REVISED RESPONSE TO REQUEST FOR ADDITIONAL INFORMATION

APR1400 Design Certification

Docket No. 52-046

RAI No.: 182-8160
SRP Section: 03.07.01 – Seismic Design Parameters
Application Section: 3.7.1
Date of RAI Issue: 08/31/2015

Figure 5. Comparison between APR1400 HRHF PSD, Target PSD and SRP 3.7.1 Rev. 4 CEUS rock target PSDs for H1H component

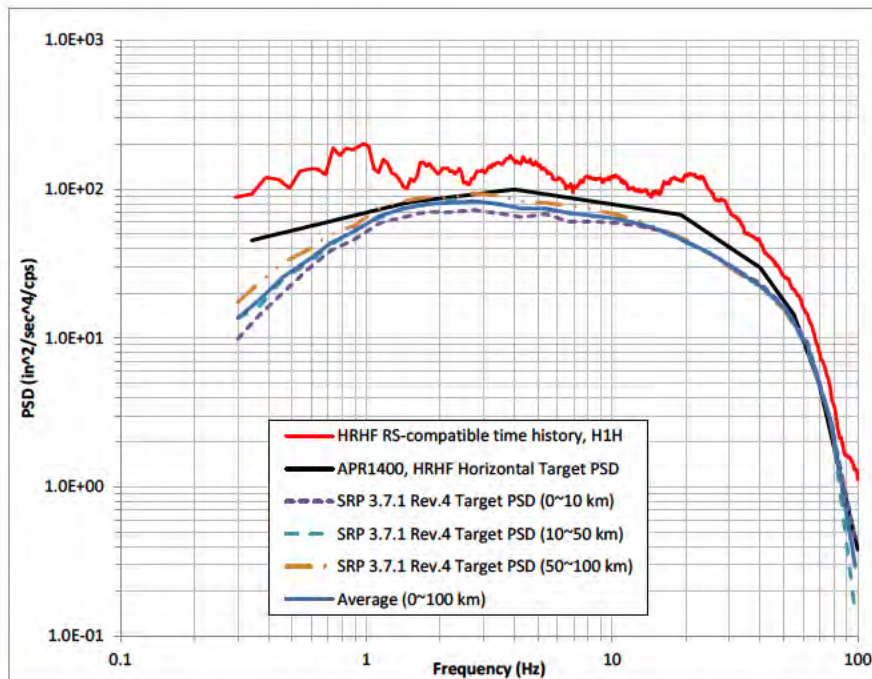
Technical report APR1400-E-S-NR-14004-P, Rev. 1 states that the APR1400 HRHF RS-compatible target PSDs were developed in the frequency range of 0.3 Hz to 80 Hz. It is understood that 0.3 Hz is consistent with Appendices A and B of SRP 3.7.1; however, the report does not provide a basis for the choice of 80 Hz. It is recently recognized during the development of Appendix B of SRP 3.7.1 Rev. 4 that the upper bound frequency in the PSD assessment should be consistent with the DRS shape. For a DRS with a zero period acceleration (ZPA) frequency, the ZPA frequency can be used as the upper bound frequency for the development of the target PSD. However, the horizontal and vertical HRHF DRS do not exhibit a definitive ZPA (zero period acceleration) frequency. As such, the applicant is requested to justify the use of 80 Hz as the upper bound frequency for the development of target PSDs.

The comparison between the HRHF horizontal time history PSD for the H1H component and PSD given in Appendix B of SRP 3.7.1 Rev. 4 is shown in Figure 5, which shows that the APR1400 HRHF time history PSD envelope the PSD given in Appendix B of SRP 3.7.1 Rev. 4.

Figure 3-11 Smoothed Ensemble-Mean PSD and Piecewise Log-Log Linear PSD Obtained from Generated 30 Time History Ensemble

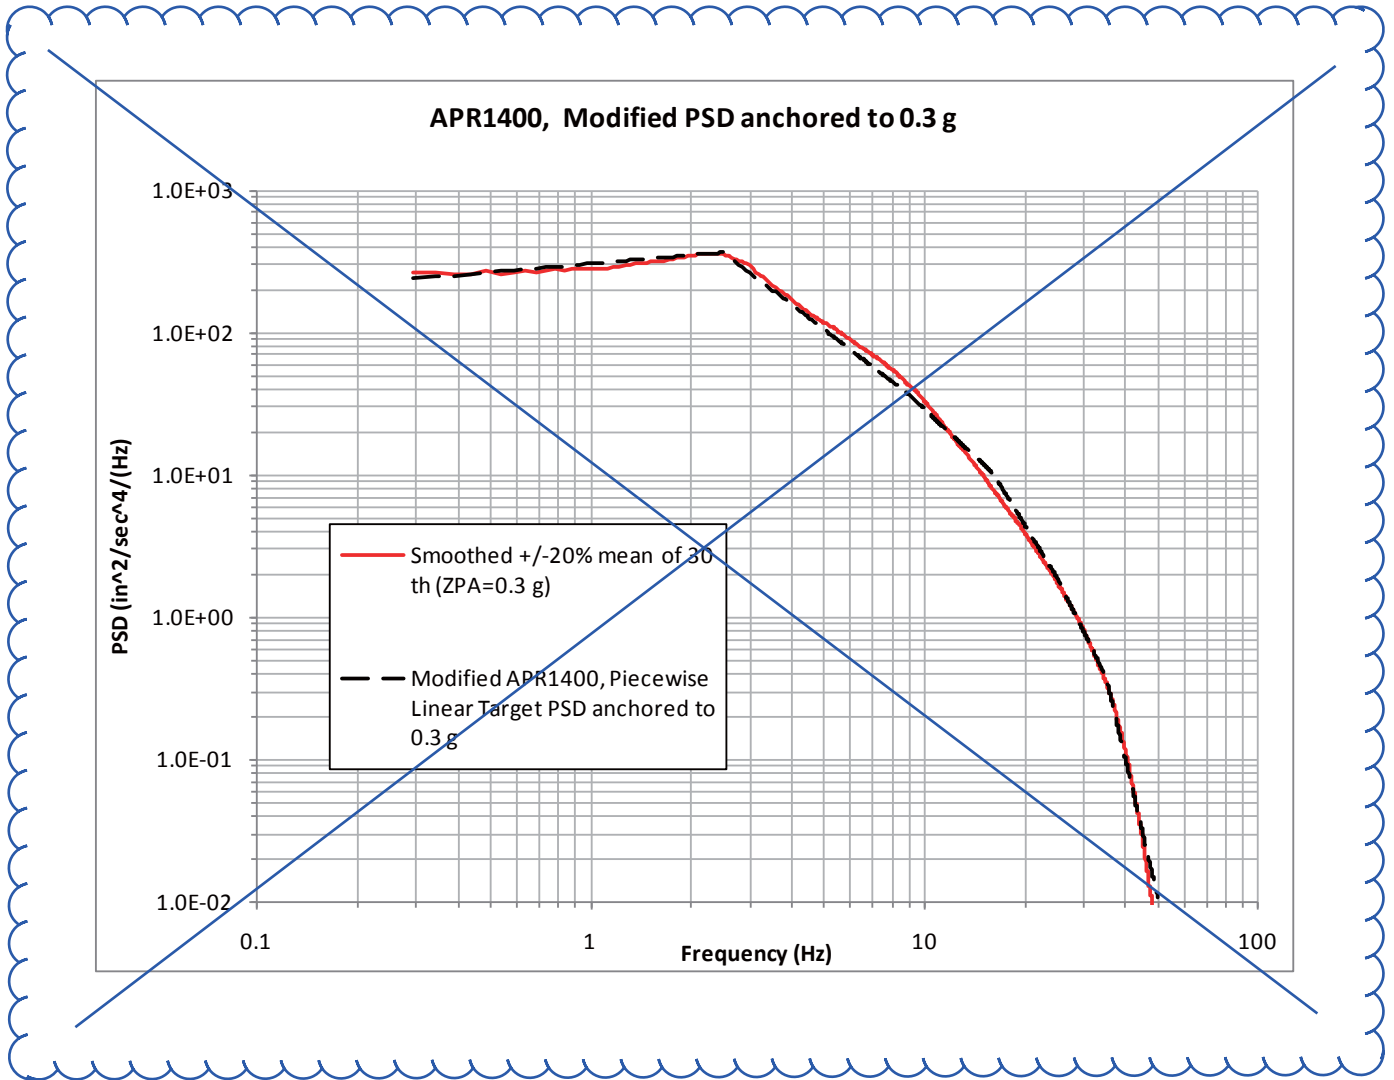
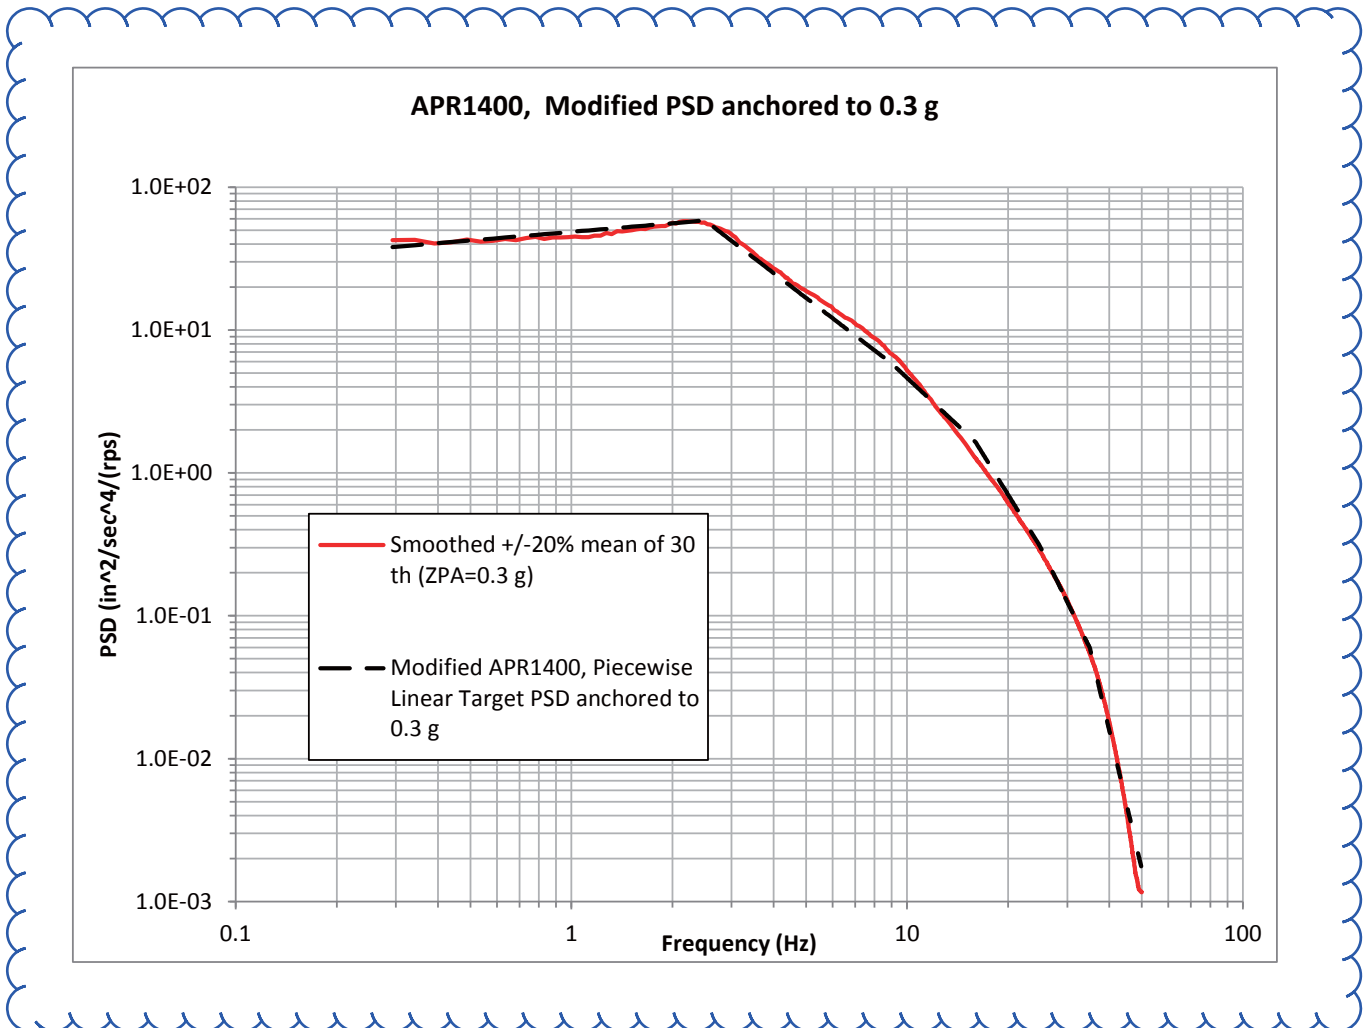
Figure 3-11 of APR1400-E-S-NR-14001-P, Rev. 0, "Seismic Design Bases" shows the smoothed ensemble-mean PSD and the piece-wise log-log linear PSD from the 30 time histories, and Figure 3-12 shows the target PSD and the minimum required PSD. Both figures are for the horizontal CSDRS anchored at 0.3 g. However, the PSD functions shown in Figure 3-11 differ significantly from Figure 3-12 (and other PSD figures after Figure 3-12). The applicant is requested to justify this difference.

- (d) A PSD function is plotted in the unit of power (in^2/sec^4) per unit frequency. If the frequency is in Hz (cycle/sec) unit, then the PSD unit is ($\text{in}^2/\text{sec}^4/\text{Hz}$). If the frequency is in rps (radian per sec) unit, then the PSD unit is ($\text{in}^2/\text{sec}^4/\text{rps}$). Since $\omega = 2\pi f$, where f is frequency in Hz and ω is frequency in rps. Thus, the PSD value in the unit of ($\text{in}^2/\text{sec}^4/\text{Hz}$) unit is equal to 2π times the PSD value in the unit of ($\text{in}^2/\text{sec}^4/\text{rps}$), i.e., $(\text{in}^2/\text{sec}^4/\text{Hz}) = (\text{in}^2/\text{sec}^4/\text{rps}) \div 2\pi$.

The PSD in Figure 3-11 is plotted in the unit of $(\text{in}^2/\text{sec}^4/\text{Hz})$. The PSD in Figure 3-12 (and other PSD figures after Figure 3-12) is plotted in the unit of $(\text{in}^2/\text{sec}^4/\text{rps})$. The PSD in Figure 3-12 multiplied by a factor of 2π will give the numerical value of the PSD in the same unit of PSD in Figure 3-11. The use of the unit of $(\text{in}^2/\text{sec}^4/\text{Hz})$ is convenient for comparison with the target PSD compatible with the target PSD for the RG 1.60 horizontal spectra. The use of the unit of $(\text{in}^2/\text{sec}^4/\text{rps})$ is convenient for checking compatibility with the time history PSD, which is computed from the Fourier spectrum in the frequency unit of rps.

Figure 3-11 of Technical Report APR1400-E-S-NR-14001-P/NP, Rev. 0 will be revised to reflect the response.
